Access Compliance Report Public Rights-of-Way (Curb Ramps)

Main Street: WOODLAWN_AVE		Cross Street: CAMEO_DR		Location:	NW
ADA ID: RPAT211011094756	Ramp Type: Type 3 - Combination 1	Initial Pass/Fail: Fail	Overall Compliance: No	Severity Score:	15
Codes/Mitigation Info/Possible Solution			Field Measurements/Component Compliance

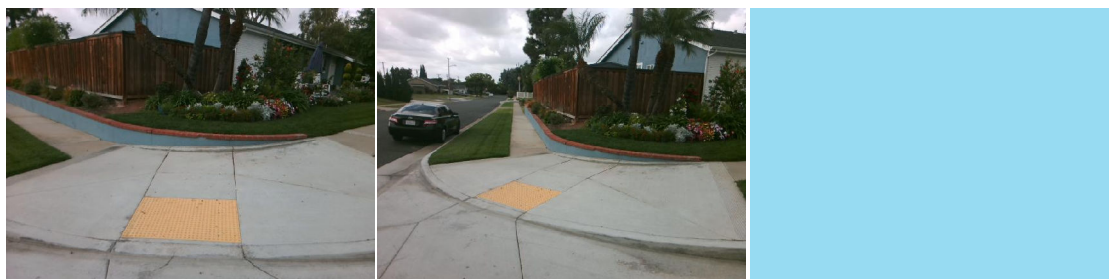
R304.2.2, R304.3.2, STD 1115

Remove & Replace Curb Ramp With Two New Directional Ramps or Equivalent.
